**July 19, 2024**

Version 2

**Low Power Mode and MIL Flashes with No DTCs Stored**

Supersedes 24-085, dated June 19, 2024 to revise the information highlighted in yellow.

## REPAIR PROCEDURE

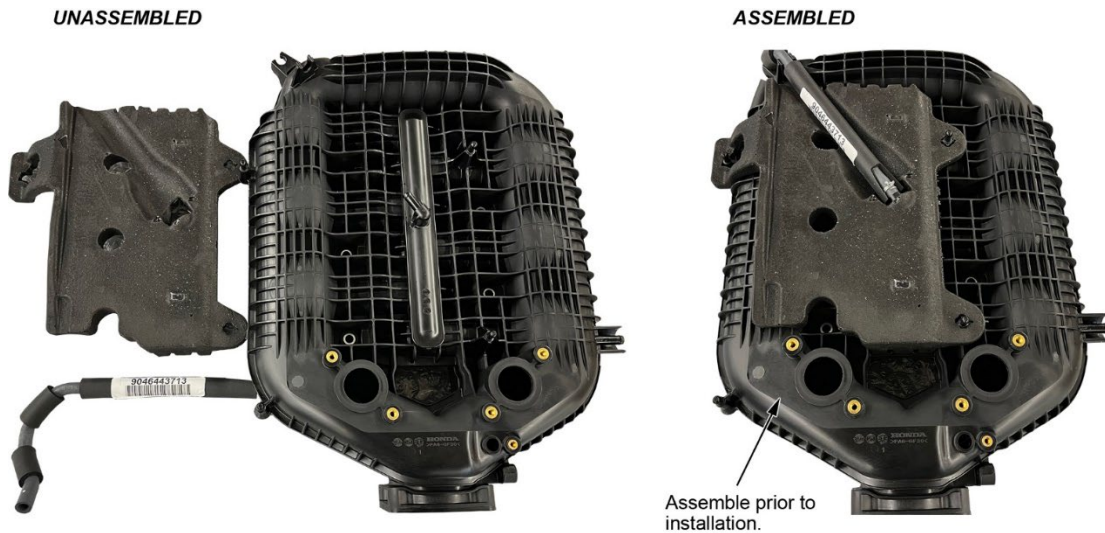
Moisture accumulation in the intake manifold during long drives gets drawn into the combustion chamber while cornering, causing misfires.

3. Install the new intake manifold, new insulator, and the new PCV hose.
